**6.2** 18 - 22 SALMON STREET, PORT MELBOURNE

**PREPARED BY:** ROSANNE MASSEY, SENIOR URBAN PLANNER

**1. PURPOSE**

**APPLICATION NO:** MINRA0009/2017 (Council)  
PA1700301 (DELWP)

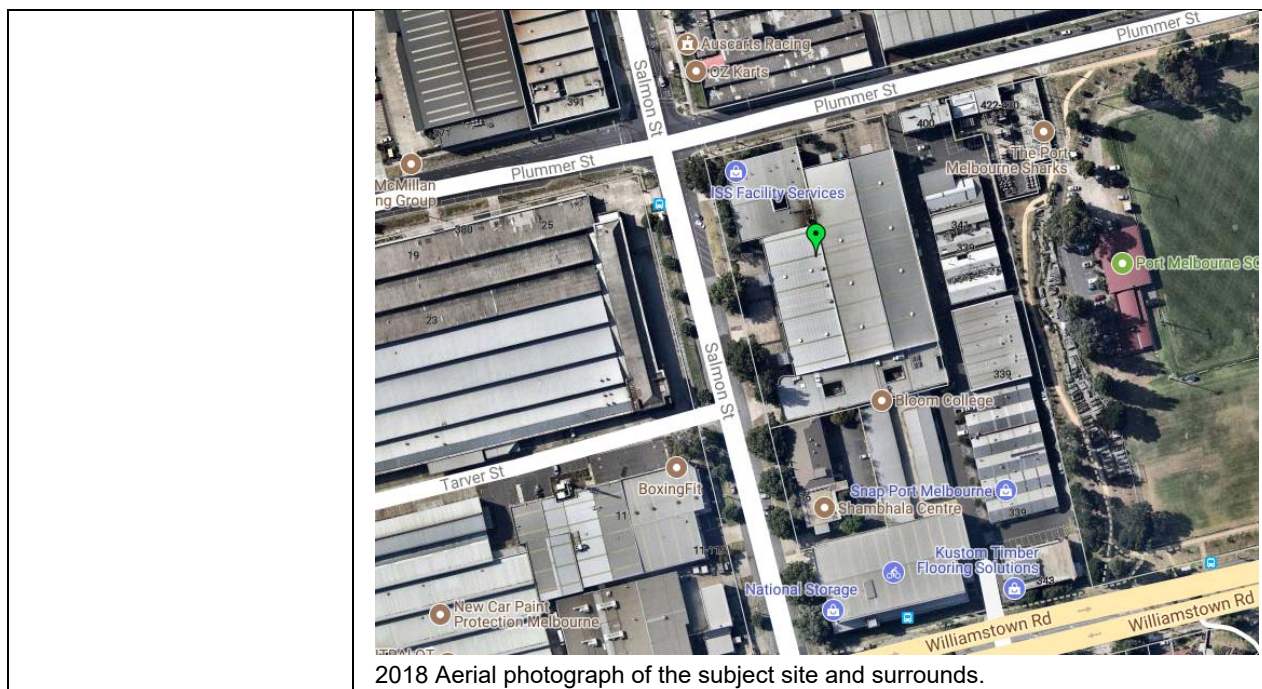
- The proposal does not include the intended public open space which is identified as being located at the corner of Plummer Street and Salmon Street within the Draft Framework Plans.

- The proposal does not include the new 12m wide road which is planned to be located along the southern edge of the subject site connecting Tarver Street to JL Murphy Reserve, and proposes crossovers to both Plummer Street and Salmon Street which are not permitted within the Draft Framework.

- The proposed plaza space appears constrained by the addition of shops within the plaza to provide active frontages. While active frontages are supported, the plaza needs to accommodate the footfall generated by the offices, retail, school, dwellings and multi-purpose space.*

- Located on one of the most prominent corners in the Wirraway neighbourhood city centre, the tower locations and heights could improve how they address the corner site and prominent views along Salmon and Plummer Streets. A variation in height has the potential to open up the corner or present a stronger corner and provide additional diversity to the built form.*
